To: Steve Foster
From: Mark Irish
Date: 12 February 2021
Subject: Horsley Logistics Park
Response to Additional DPIE RFI

At: ESR
At: SLR Consulting Australia Pty Ltd
Ref: 610.19360-M04-v0.3 Additional DPIE RFI
Response.docx

ESR is proposing to develop a new industrial estate, the Horsley Logistics Park (the development), that will be located at 327-335 Burley Road, Horsley Park, in New South Wales (NSW). SLR Consulting Australia Pty Ltd (SLR) has been engaged by ESR to prepare a Noise and Vibration Impact Assessment (NVIA) for the development to assess potential noise impacts associated with the construction and operation of the project. The report forms part of the State Significant Development Application (SSDA) for the development.

Following submission of the NVIA, the NSW Department of Planning, Industry and Environment (DPIE) has provided a Request for Additional Information by email on 19 January 2021, reproduced below. This memorandum includes SLR response to the DPIE RFI.

Figure 1 Lot 201 Vehicle Source Locations – Access Road and Loading Area

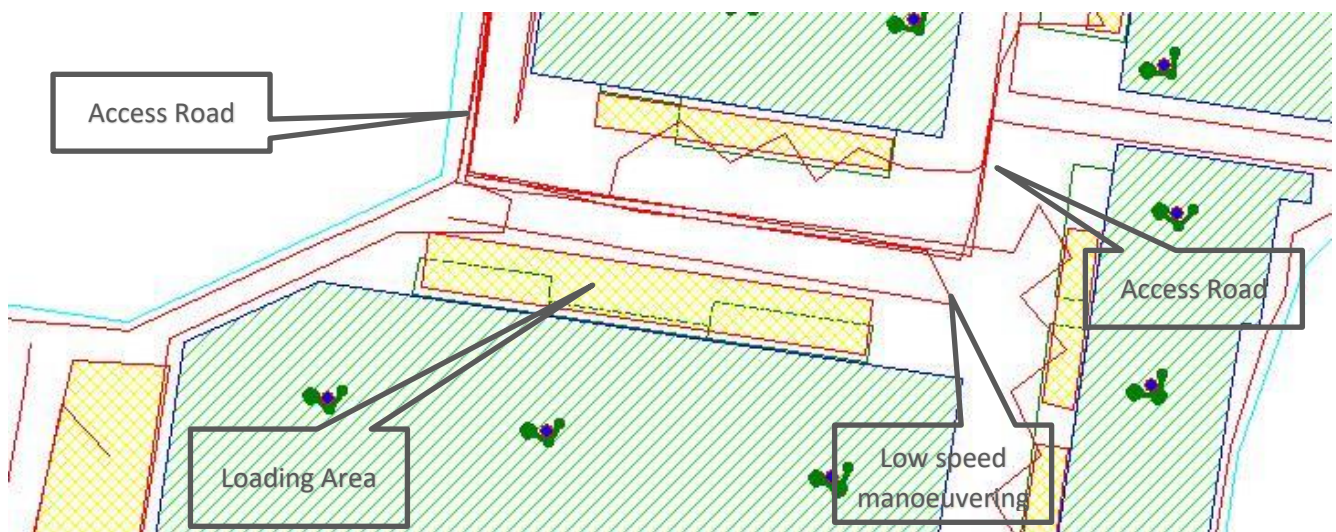
Loading docks are anticipated to be utilised by 19 metre semi-trailers for reversing movements and super B-double for side-loading. However, there is no evidence that all heavy vehicle manoeuvres identified in the transport assessment have been taken into account in the operational noise assessment.

The NVIA must be revised to incorporate each distinct outdoor operation corresponding to side-loading as well as heavy vehicles idling, passing by, accelerating and reversing (including the contribution of energy-average noise emission associated with non-tonal reversing alarms). This would involve changes to modelled sound power levels for onsite vehicle movements and source path footprint. In addition, the representative duration of noise emission for each distinct operation also need to be amended accordingly. It should be noted that it is unlikely articulated trucks and B-doubles would be able to manoeuvre safely at 25 km/h when turning and reversing on site.

A sensitivity analysis has been conducted to confirm whether the current modelling assumptions include sufficient allowance for the increased sound power levels associated with low speed activities in the loading and hardstand areas.

The relevant locations for the vehicle movement path (using Lot 201 as an example) are shown in **Figure 1** below.

The source SWLs in **Table 1** indicate the SWL associated with each of the vehicle manoeuvring and loading scenarios. Lot 201 night-time peak has been used as an example but the same principle would be applicable to each Lot within the estate.

The source contributions in **Table 1** indicate that the existing modelling assumption provides a reasonable estimate of the overall sound power level to account for a variety of different vehicle speeds and reversing alarm activity. The only scenario which anticipates a slightly higher SWL (a negligible 1 dB increase) is Scenario 4 with a 25 km/h speed limit on all access roads, together with reversing alarms operating for 30 seconds per vehicle on average.

Figure 2 NCA 01 Receiver Location

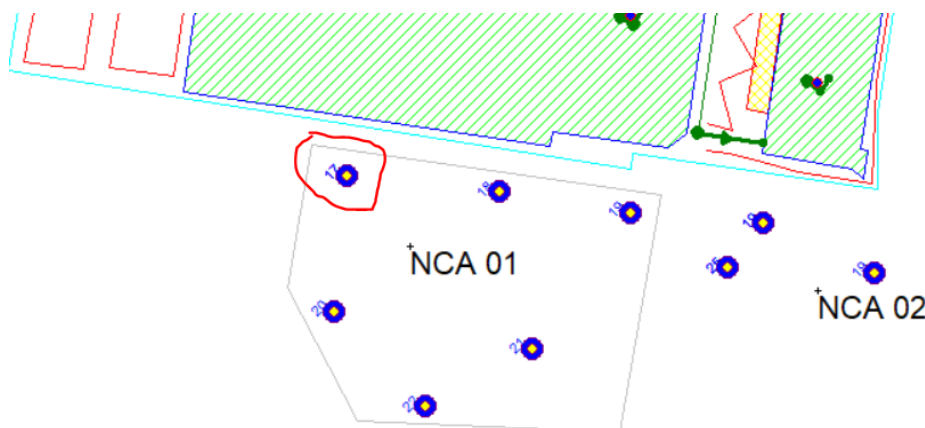
Given the NVIA reported exceedances of sleep disturbance screening criterion at all residential assessment locations and that the predicted temporal variation in noise is well above 5 dB within a 15-minute assessment period, the Department considers the application of a +5 dB modifying correction for intermittent noise to be warranted.

To assess whether the reversing alarms are likely to be dominant in a peak scenario, the following source contributions are provided for one example receiver in each of NCA 01 (Table 3) and NCA 02 (Table 4). These are the most significant noise sources at this location which contribute to the overall ambient noise level. The predicted noise levels are for night-time, weather enhancing conditions as this is the controlling time period for the assessment.

The results above indicate that the noise contribution from any individual reversing alarm is around 6 dB or more below the overall receiver noise level. Whilst reversing alarms are significant in terms of noise contributions, when considered in the context of other noise sources operating across the site and the overall LAeq receiver level they would not be considered individually dominant.

Figure 4 Lot 204 Loading Area – Extended Canopy Wall

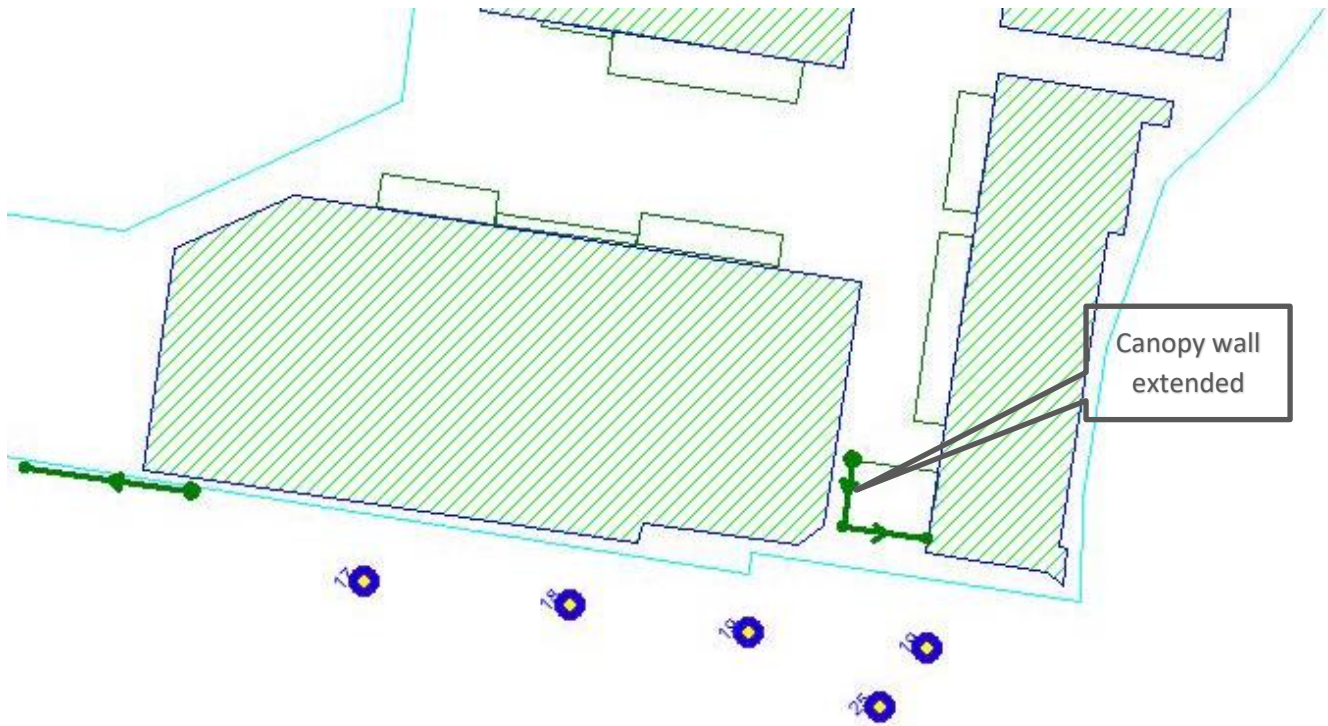
However, a scenario has been identified where a reversing alarm operating on the southern Lot 204 loading area could be considered intermittent at the nearest receiver in NCA 02.

Additional attenuation of a reversing alarm with the Lot 204 loading area has been investigated by means of an extension to the canopy wall (to eave height) as indicated in **Figure 4** below.

Individual reversing alarms in Lot 204 were re-modelled with the results included in Table 10.

In this mitigated scenario it is predicted that a 5 dB intermittency correction would no longer be applicable in the night-time peak or Lot 201 and 204 reduced activity scenario as indicated in **Table 11**.
